# UPDATE Technical Bulletin

## UPDATE – 55i3 Fuel Door (NVLW)

UPDATE 55i3 - Fuel Door (NVLW)

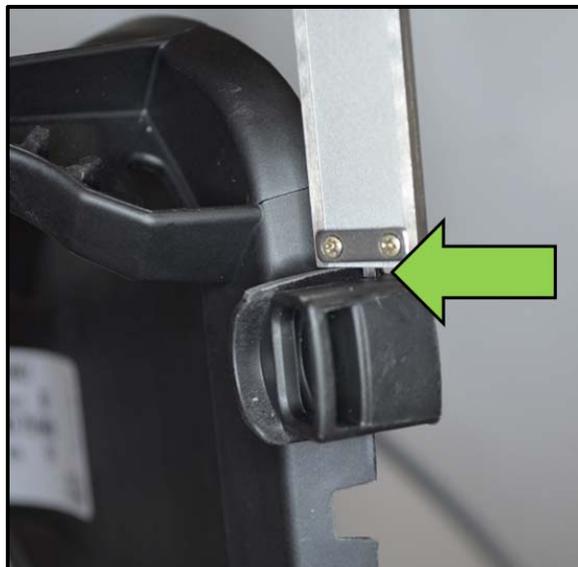
- Open the fuel filler door.
- ⇐ Insert a pocket screwdriver (or equivalent) as shown <circle>, and release the locking tab.
- While holding the locking tab in the released position, carefully pull the painted cover directly away from the vehicle.
- Slide the painted cover about 3mm to release it from the hinge assembly, then remove the painted cover from the vehicle.

- ⇐ Use a Vernier type caliper (or equivalent) to measure the height of the lip as shown <arrow>.
- If the lip is less than 1.7mm high, **Work Complete**
- If the lip is 1.7mm or higher proceed with the rest of this section.

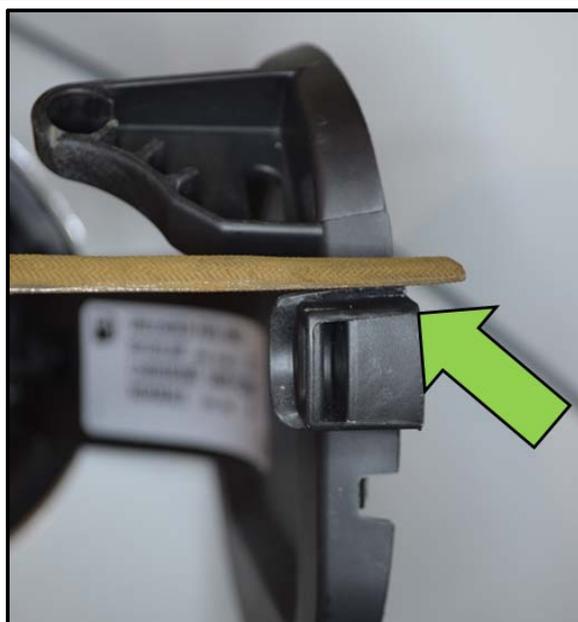
- ⇐ Use a flat file (or equivalent) to file down the lip as shown <arrow>.
- Re-measure the lip as necessary and verify it is shorter than 1.7mm.
- Repeat the filing procedure and re-measure the lip as necessary until it is the proper height.

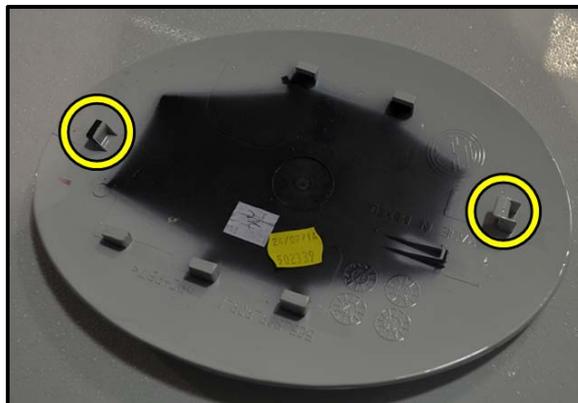
- ⇐ Reinstall the painted cover onto the fuel filler door hinge.

⚠ **Note:** The cover is positioned so that locking tabs <circles> point TOWARD the vehicle.
